**MEETING PACKET FOR
THE REGULAR MEETING OF
MONDAY, MARCH 9, 2026
7:00 P.M.**

**2036th Regular Meeting Agenda of the Council of the City of Livonia
Monday, March 9, 2026**

1. [WAIVER PETITION: Petition 2024-02-02-03, submitted by Stonefield Engineering & Design on behalf of Haggerty Six Partners, LLC, seeking approval of all plans in connection with Buildings F and I, pursuant to Council Resolution #135-24, which previously approved a waiver use at the Shoppes at College Park as part of a Planned General Development, located on the north side of Six Mile Road between Haggerty Road and Fox Drive in the Southwest ¼ of Section 7. \(Approving\)](#)

WAIVER PETITION: Petition 2024-02-02-03, submitted by Stonefield Engineering & Design on behalf of Haggerty Six Partners, LLC, seeking approval of all plans in connection with Buildings F and I, pursuant to Council Resolution #135-24, which previously approved a waiver use at the Shoppes at College Park as part of a Planned General Development, located on the north side of Six Mile Road between Haggerty Road and Fox Drive in the Southwest $\frac{1}{4}$ of Section 7.

Principal in Charge:
G.B.
Project Manager:
WLS
Drawn By:

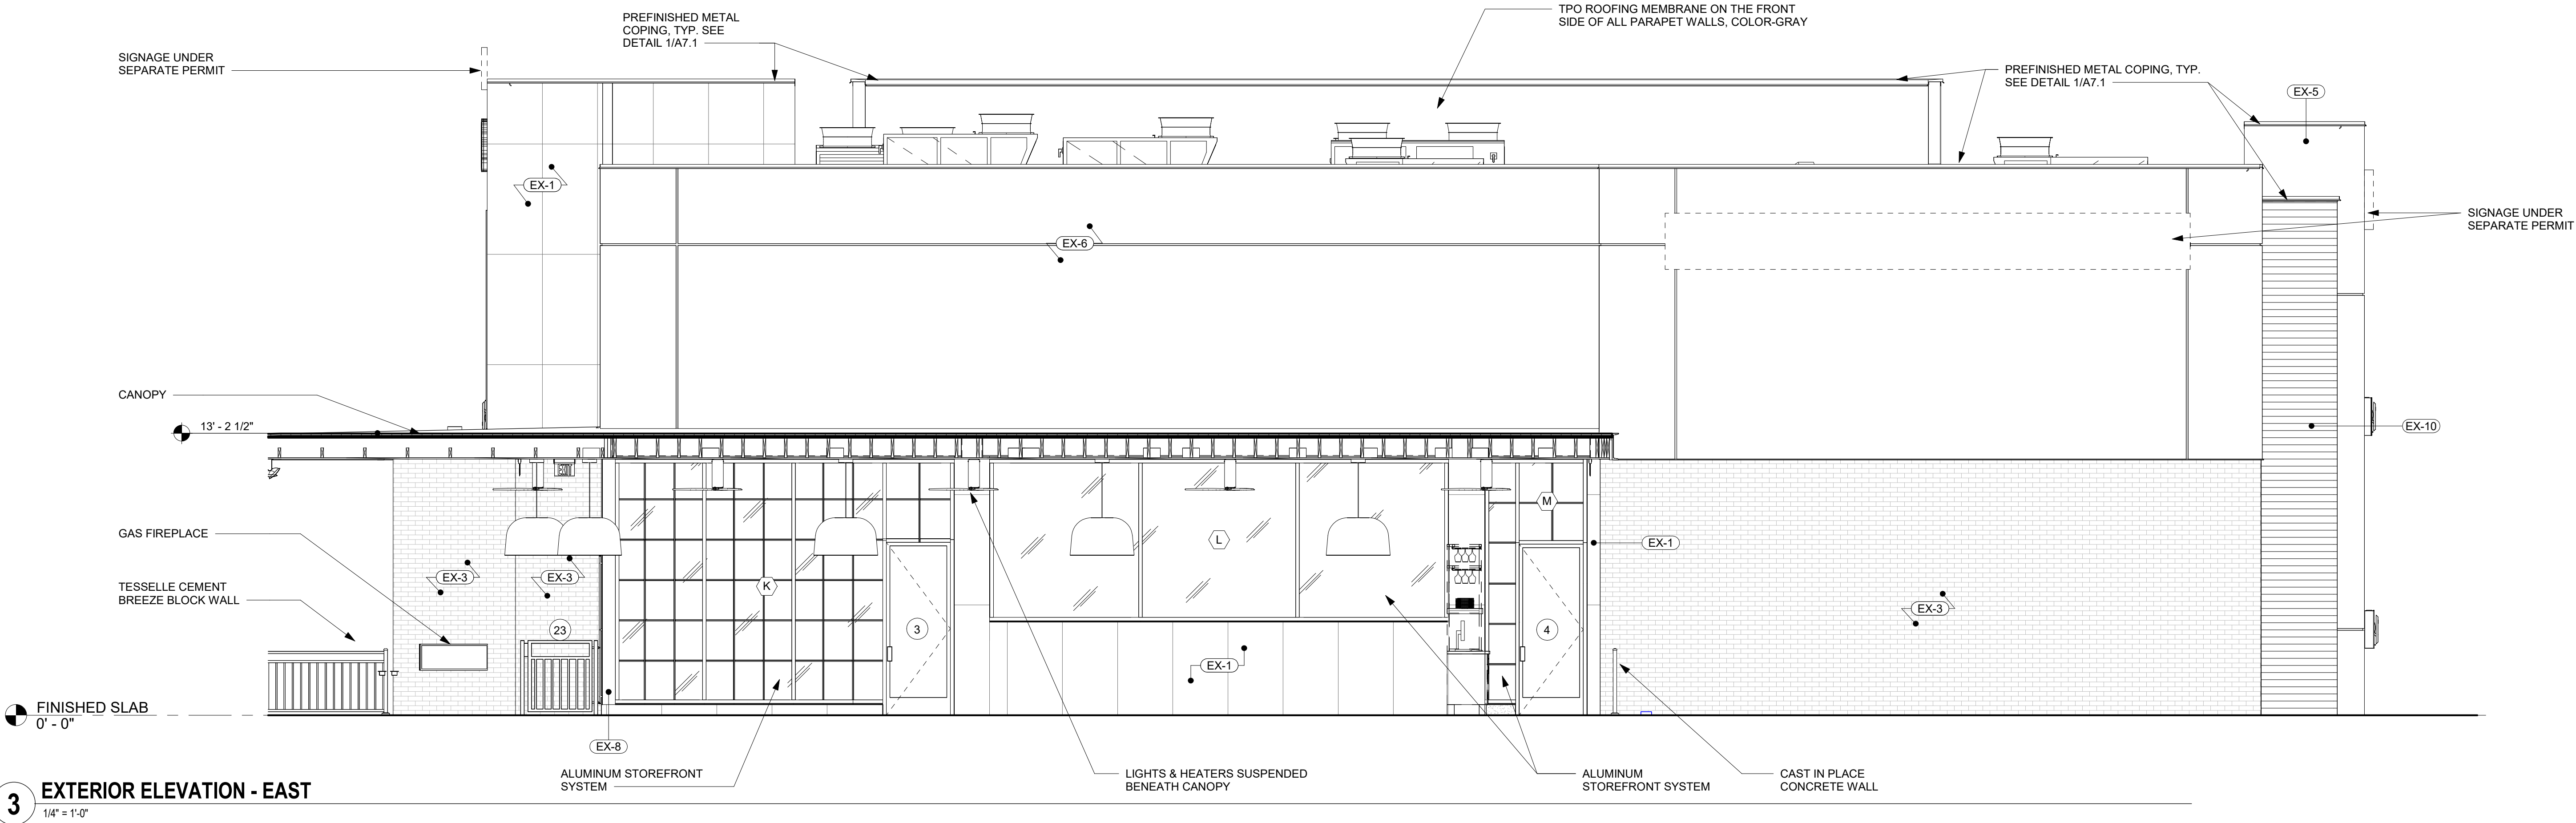
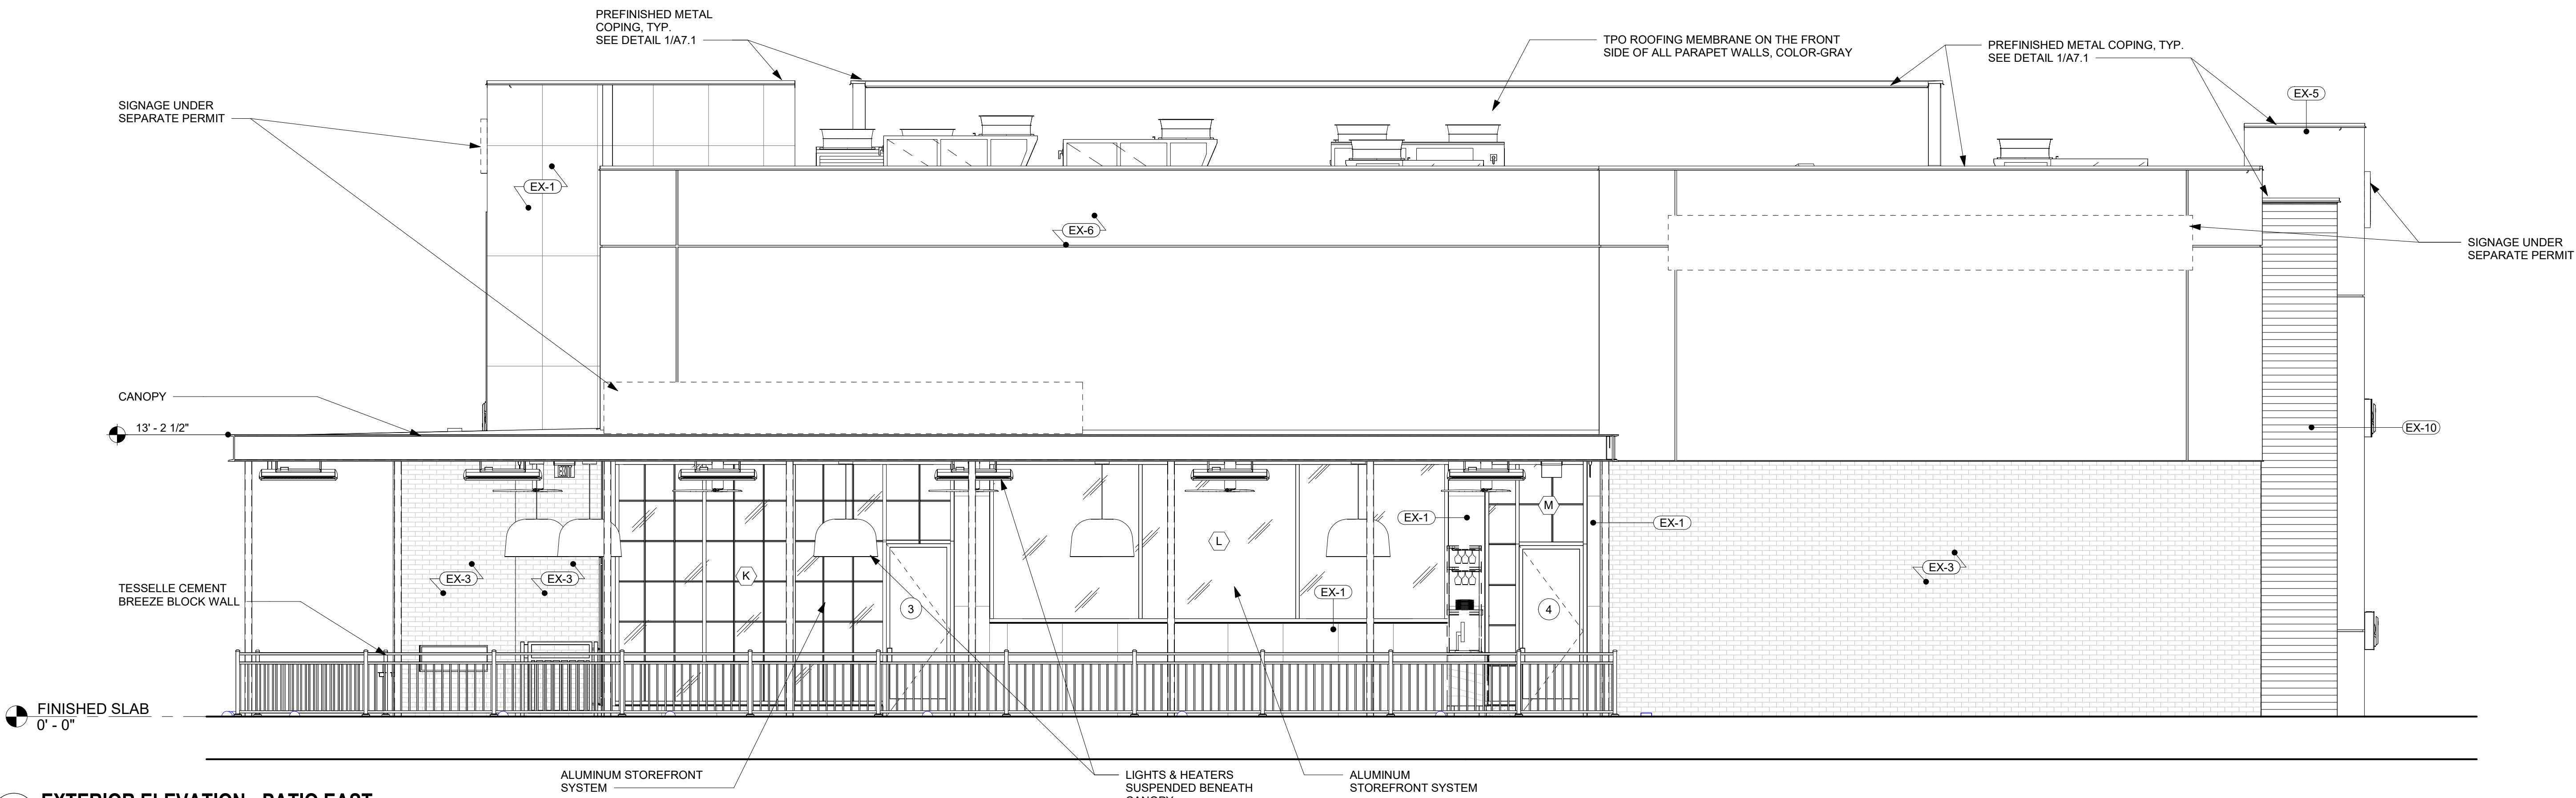
5. The Exterior Elevations and Floor Plan for Building I on Sheets A4.0, A4.1, A4.2, and FS1, dated October 9, 2025, prepared by Innovation Architecture, is hereby approved and shall be adhered to, provided that the exterior stucco portions of Building “I” be revised to the satisfaction of the Planning Department with materials equal in quality and character to those being employed on Building “F”,
